Statement of Basis

Permit to Construct No. P-2009.0092

**Idaho Power Company - Langley Gulch Power Plant
New Plymouth, Idaho**

August 14, 2013

Figure 1 – Change Dry Chemical Storage Silo Modeling

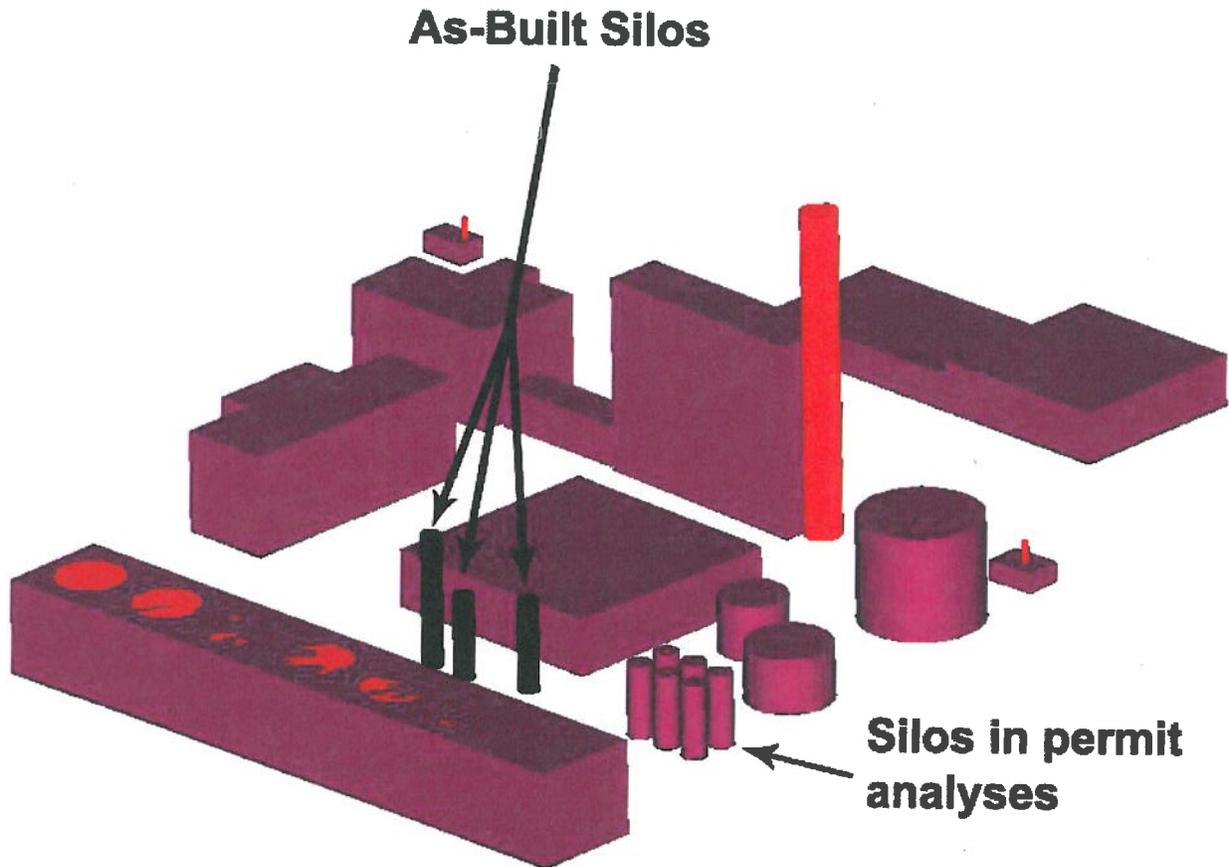
Release parameters for the dry chemical storage silos changed substantially from what was originally modeled for the current permit. The following are changes from how the silos were originally modeled:

- Original modeling included six silos, and final design was only three silos.
- All six originally modeled silos had exhaust release points at 36 feet, while the final designed silos were 65.4 feet for the lime silo, 44.6 feet for the soda ash silo, and 41.3 feet for the magnesium oxide silo.
- Exhaust flow from the originally modeled silos were 1,000 actual cubic feet per minute while final design was 1,200 actual cubic feet per minute.
- The location of the chemical storage silos changed, with the final design location about 30 meters to the northwest of the originally modeled location. Figure 1 shows the change in the location, height, and number of storage silos.

Figure 2 – Actual Source and Building Locations vs. Modeled Locations

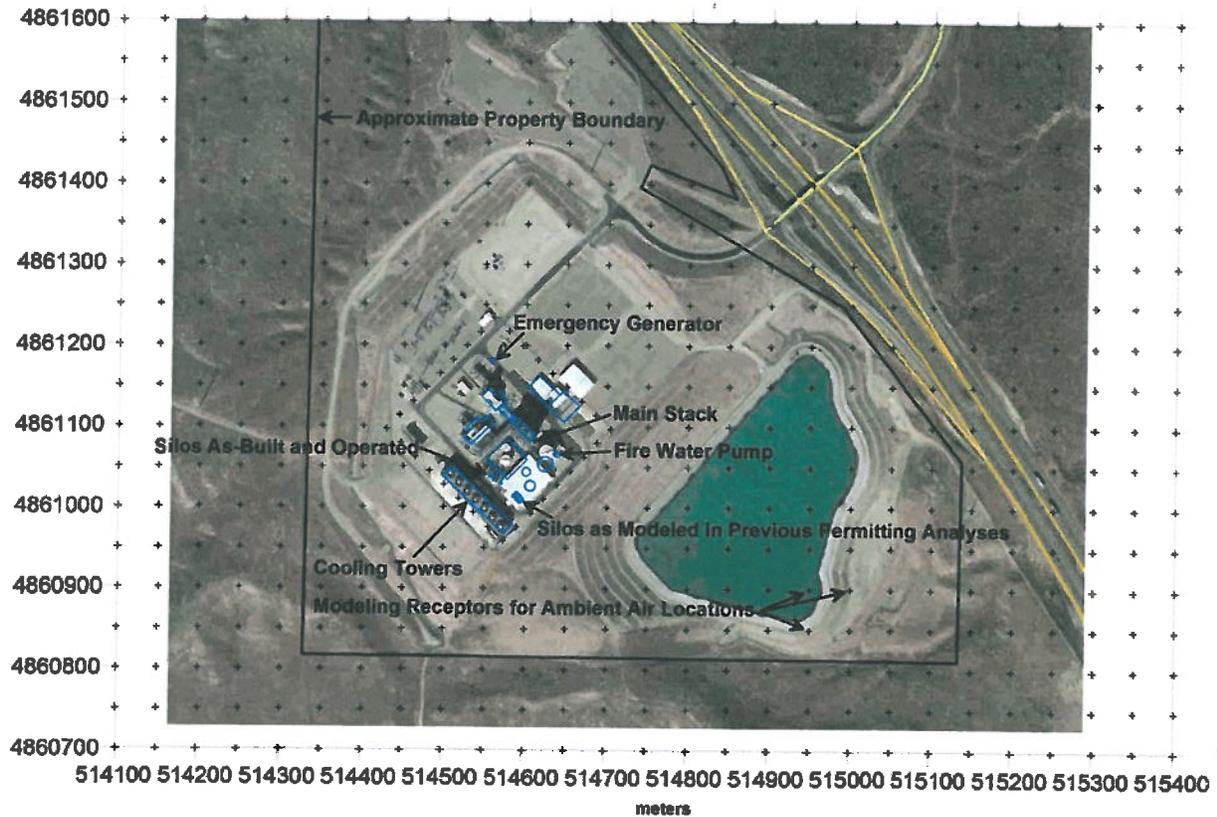
Figure 2 shows how the location of emission sources and structures in the modeling analyses supporting the current permit differed from what was actually constructed. Actual source and building locations are shown in the aerial photograph and the locations as modeled in the previous analyses are outlined in blue.

The most substantial difference observed in the figure is the change in the location and number of dry chemical storage silos. The location of the emergency generator also appeared to be different. Several buildings and tanks were constructed in substantially different locations than depicted in the model, which could alter plume downwash effects.

DEQ verification analyses did not completely or accurately correct the identified source/building location issues. DEQ revised the analysis by visually relocating sources and buildings to better match what was built, as indicated by the aerial photograph. DEQ did not obtain revised building coordinates verified by the applicant. The verification analysis was run to provide an idea of how changes in the source/building locations could potentially affect model results.

Figure 3 – DEQ 24-Hour PM₁₀ Verification Analysis

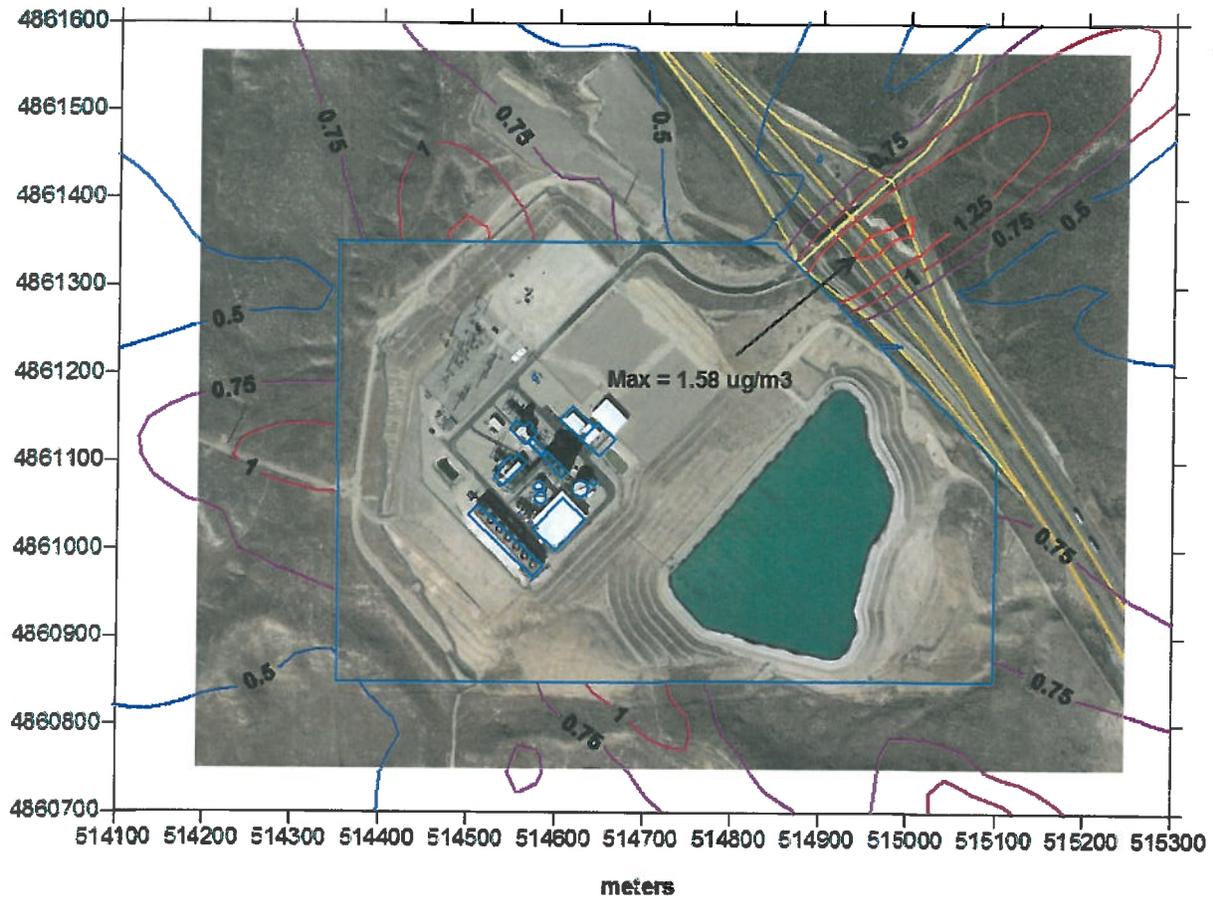
Figure 3 shows results from the DEQ 24-hour PM₁₀ verification analysis. The maximum 24-hour PM₁₀ concentration was predicted at 1.58 µg/m³ at a location immediately northeast of the site. This value is less than the 1.87 µg/m³ maximum PM₁₀ concentration from the analysis supporting the current permit, and it is much less than the 3.18 µg/m³ impact conservatively calculated by using the emissions ratio method described in Section 3.4.2 and Attachment 3.

Although the model inputs of building dimensions and the ambient air receptors for the DEQ verification analyses were not highly accurate compared to what is typically used for permitting analyses, results from the verification analysis provides additional confidence that revisions in permit-allowable emissions and the deviations in site layout from what was used in preconstruction analyses will not result in ambient air impacts that exceed the SIL (except for 1-hour CO, which required a cumulative NAAQS analysis for the impact analysis supporting the current permit).
